**METROPOLITAN DEVELOPMENT COMMISSION
REGIONAL CENTER HEARING EXAMINER**

STAFF REPORTS FOR SEPTEMBER 15, 2022

REGIONAL CENTER HEARING EXAMINER - HIGH IMPACT CASE

Case Number	2022-REG-057
Address (approx.)	430 South White River Parkway, West Drive
Location	Center Township, Council District # 16
Petitioner	Elanco US Inc., by Alex Intermill
Zoning	CBD-S (RC)
Request	Regional Center Approval to provide for Phase One of Elanco Global Headquarters – a six-story office building, laboratory, innovation, and collaboration buildings, even lawn area, courtyard, and a three-story parking garage.

Floor plan – podium level (top); and first level

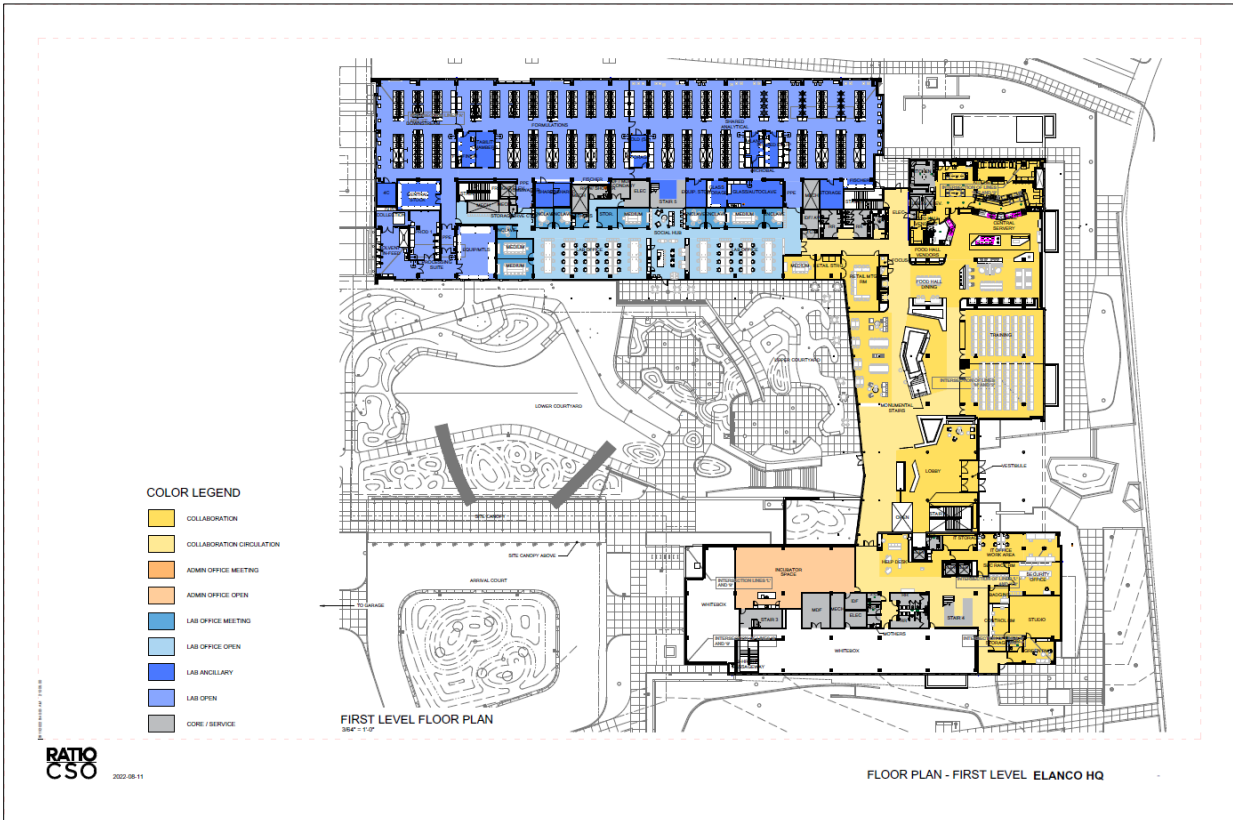
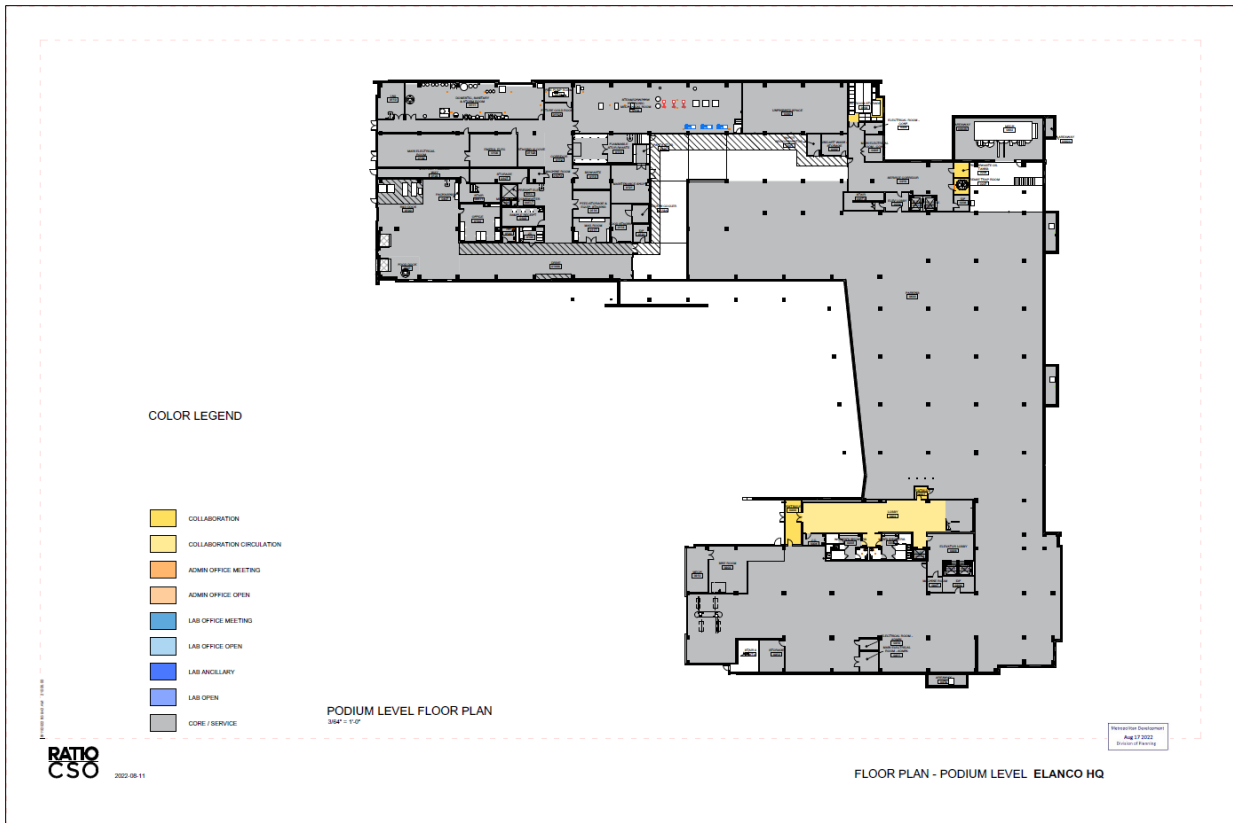
2. The office building's first level (as noted on the floor plans), along Henry Street, should include additional windows in the area identified as 'whitebox'. Guideline CA 2.1.3 indicates that windows should comprise of 40% of the length of the grade level and at two to eight feet of grade level. Staff understands that the first level noted on the floor plans would be essentially the second level along the street as the podium level would be the parking area within this building; however, additional windows should be considered as close to the ground level as possible to soften the building along Henry Street. Guidelines SC 1.3.2, and CA 2.1.3 apply.
